TENDER 19-08

HWY 19A PHASE III WATERMAIN & FORCEMAIN

ADDENDUM NO. 2

March 28th, 2018

CCR DWG #
CCR19-501-C-4

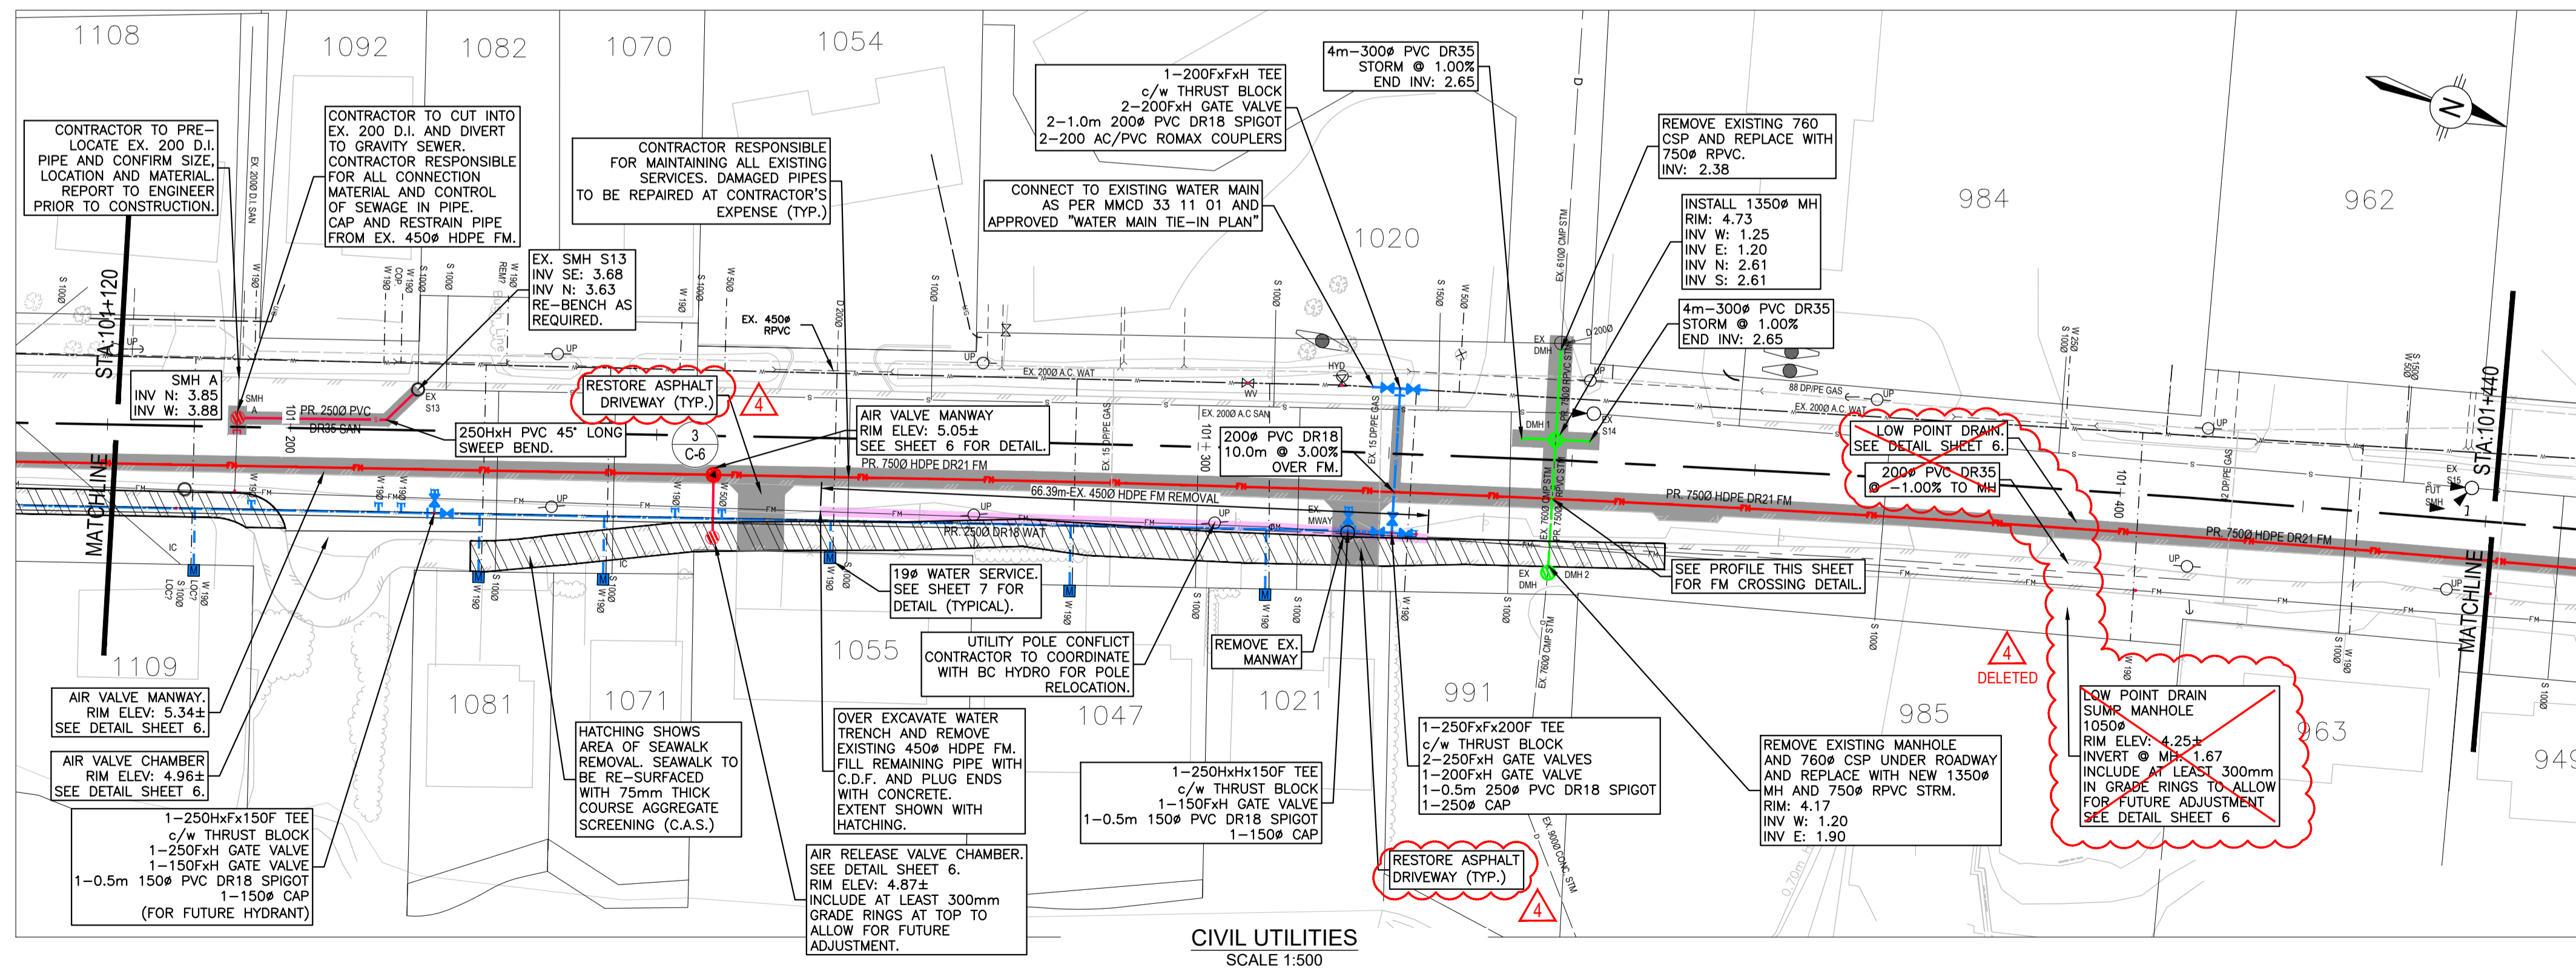
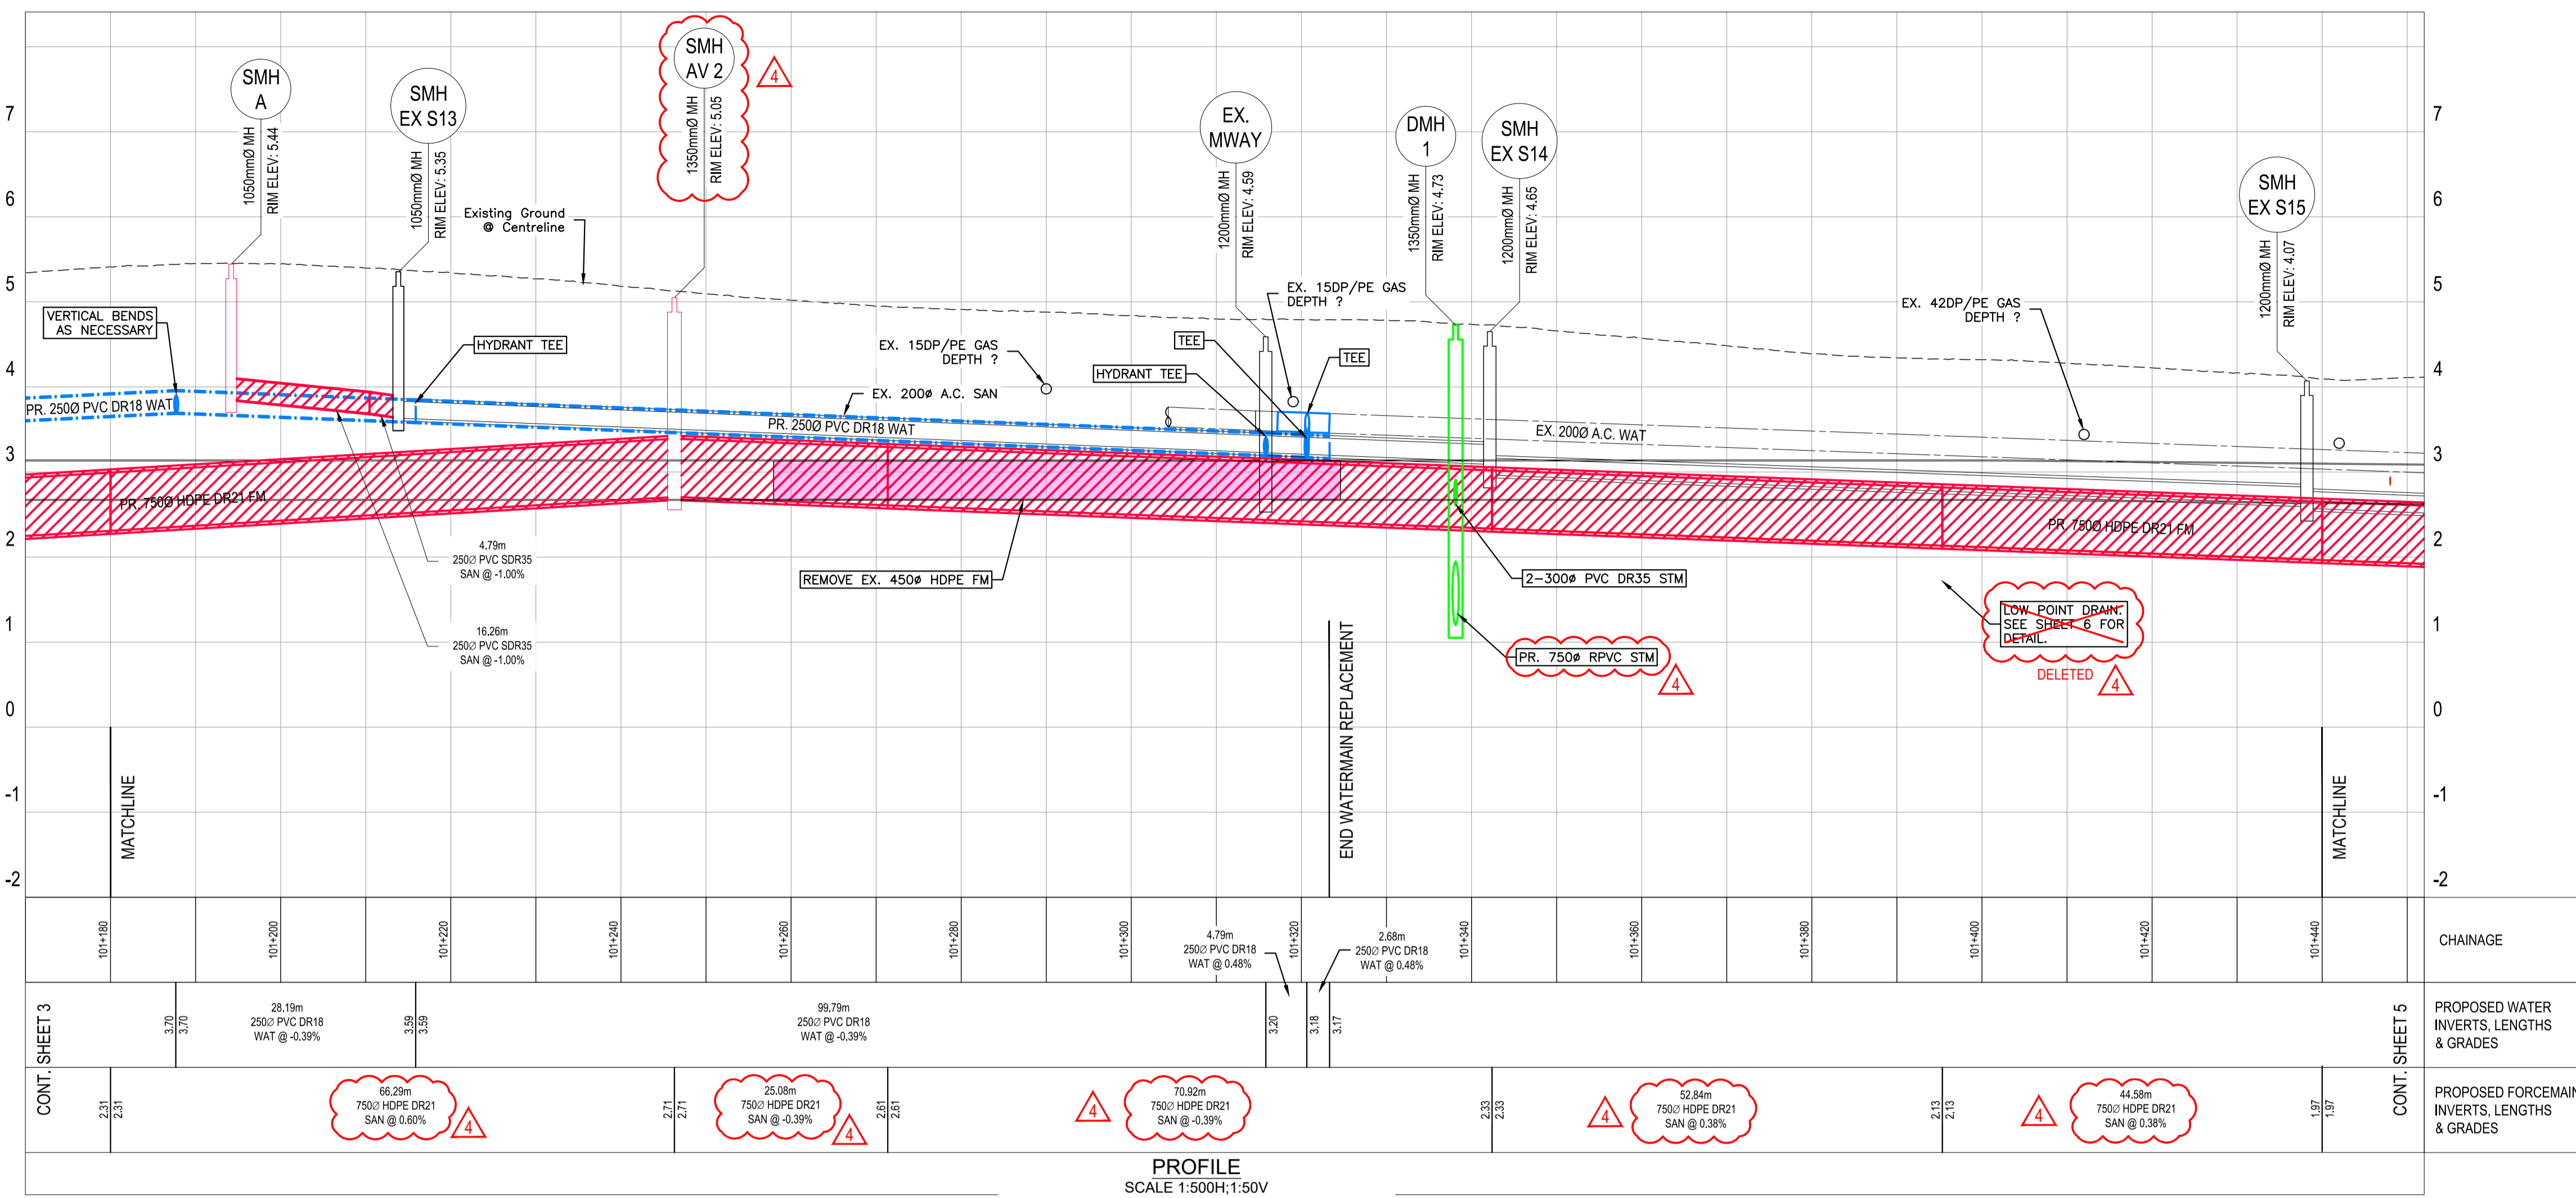
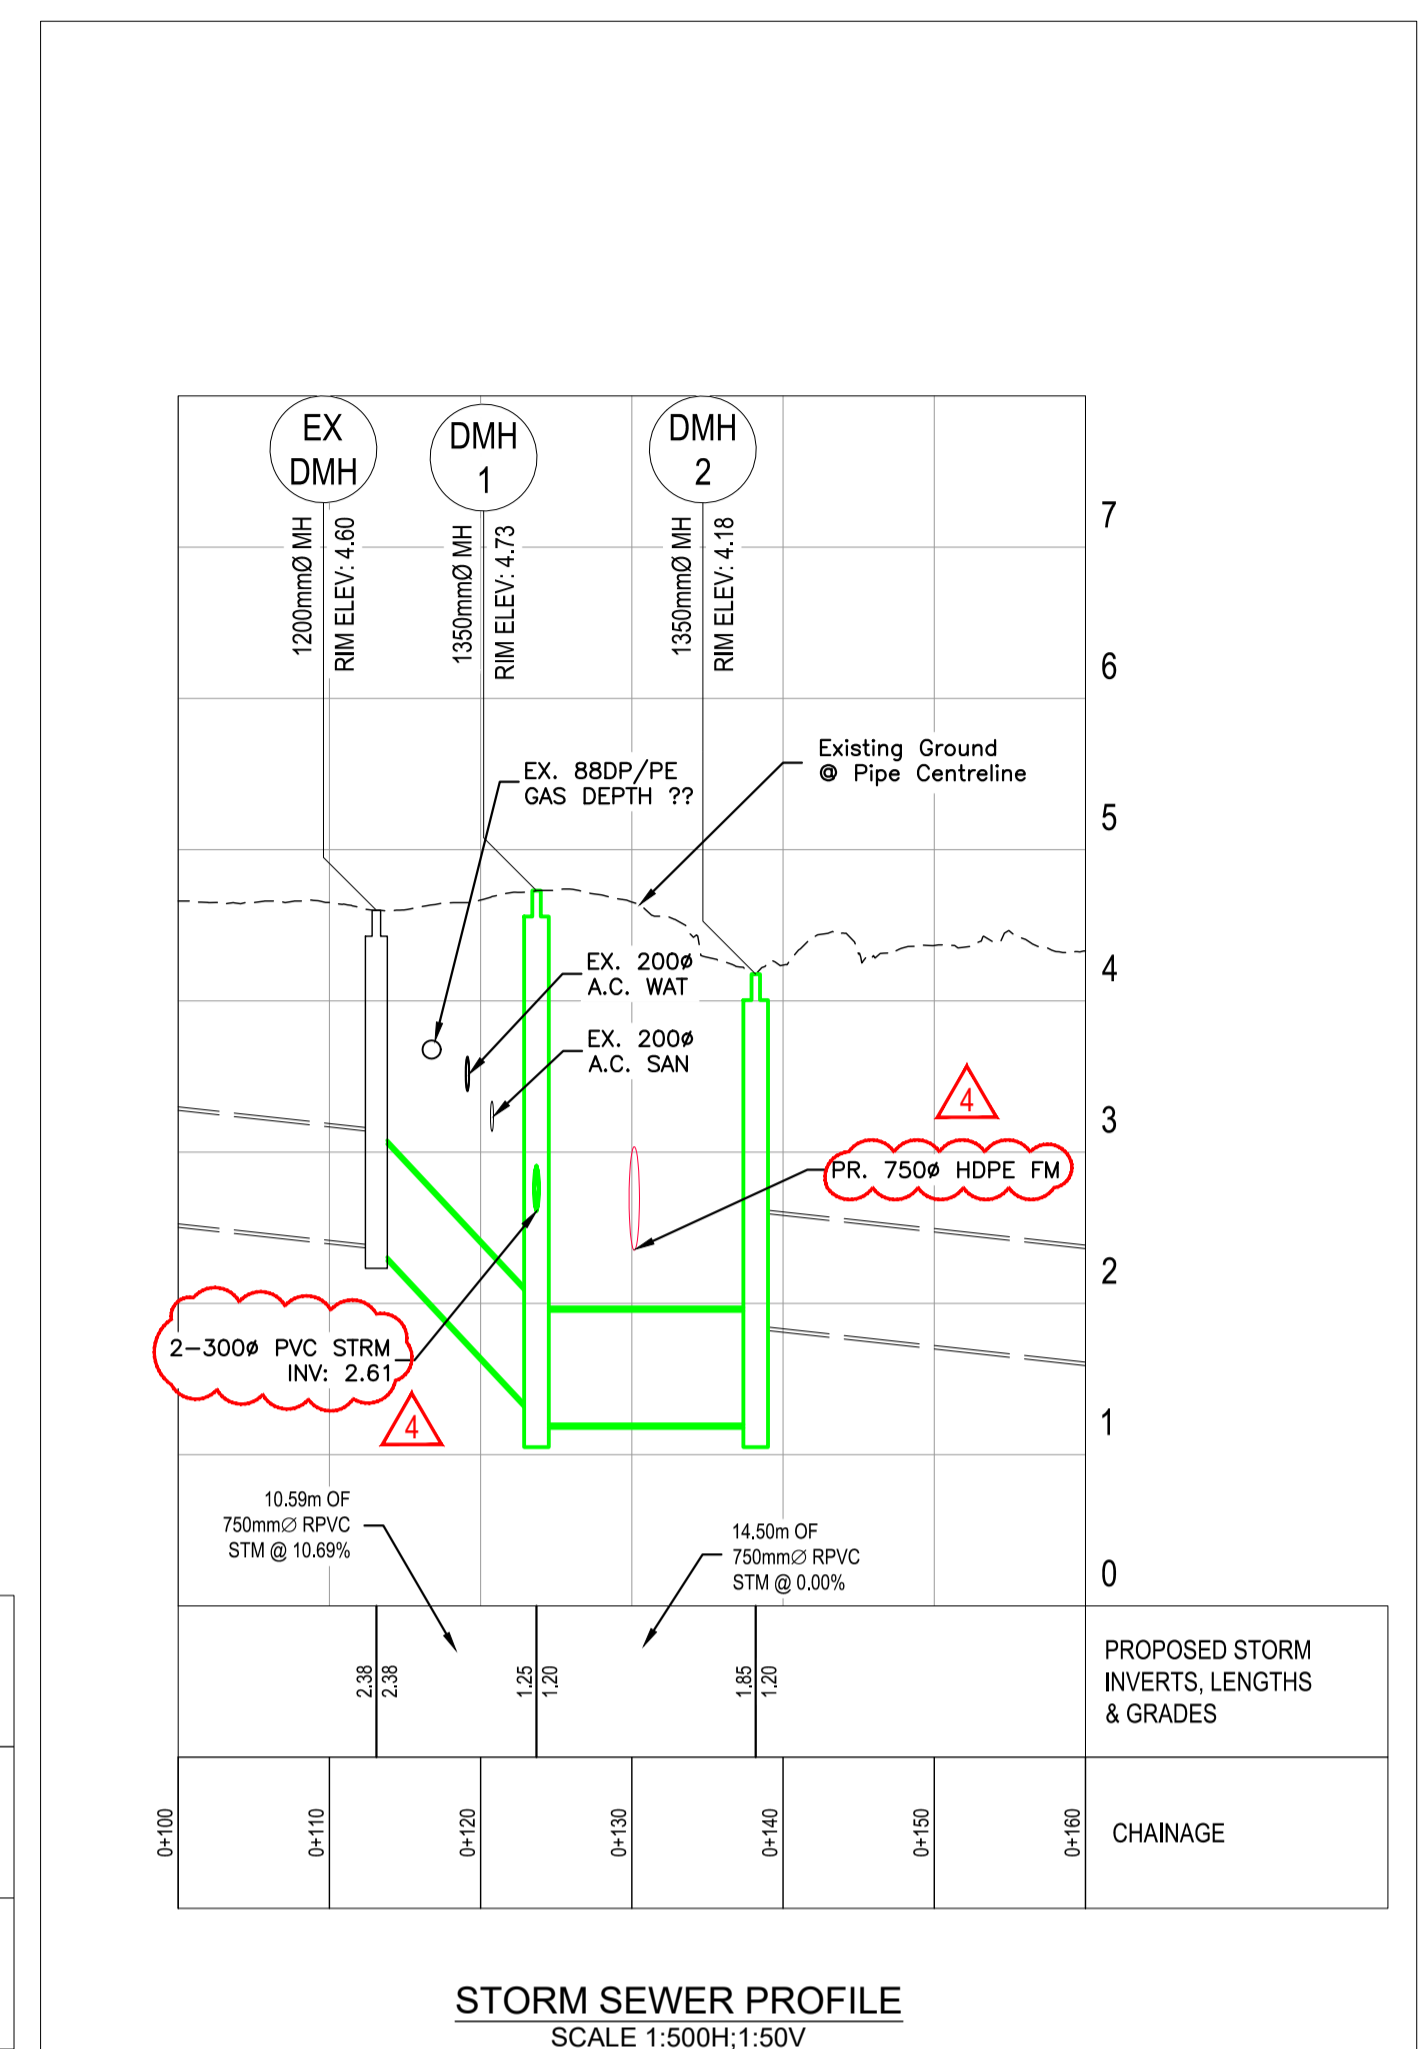
On drawing C-4, roughly sta 101+190, there is a 200mm DI San that we eventually tie into the gravity sanitary system. Does this 200mm DI line current connect to the 450mm FM? If so, is there a valve at the existing tee connect to the 450mm FM?

Record drawings and field survey do not show a valve at this location. It is assumed that there is no valve and that this line is under back pressure from the forcemain.

2 WEST SIDE WATER SERVICE (190-500) DETAIL
SCALE: HNTS
VNTS

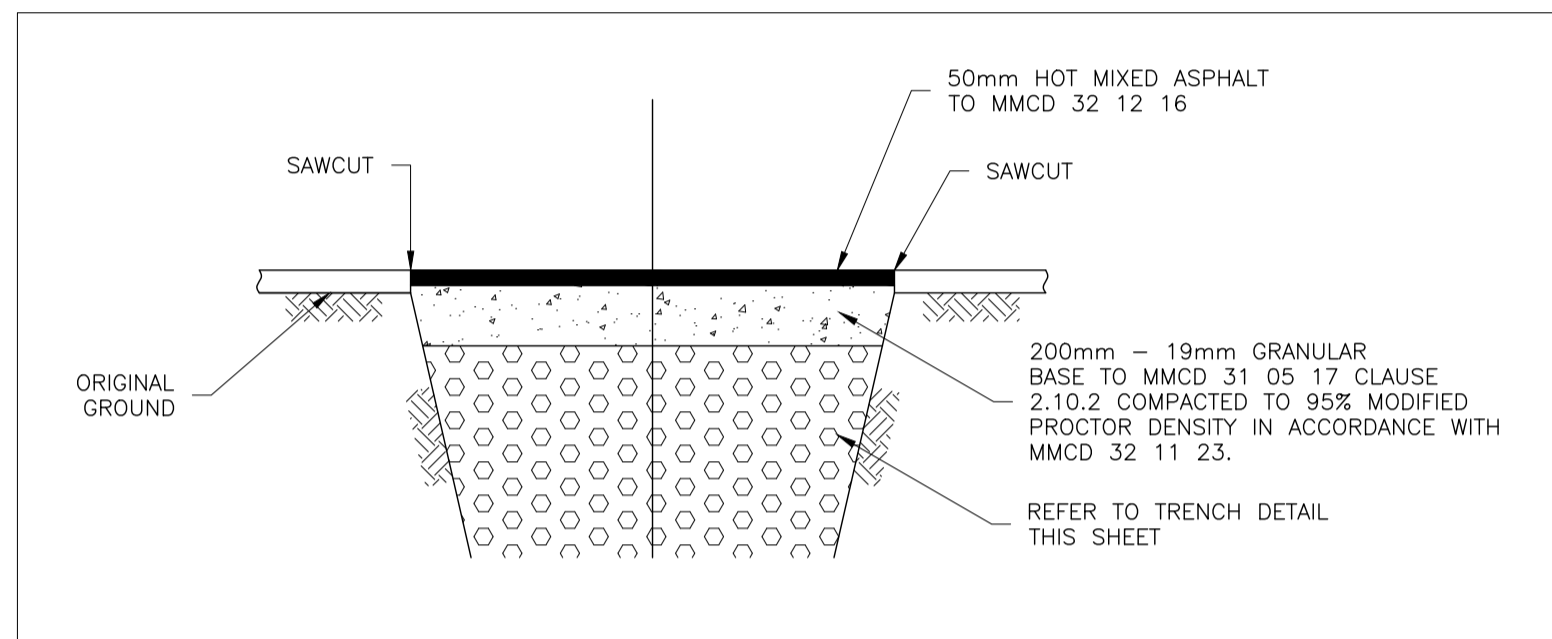
For the irrigation, are we to price CR-I102?

The 50mm water services for irrigation are to be installed per Detail 2, Sheet C-7. They are to be used in future work scheduled for 2020.
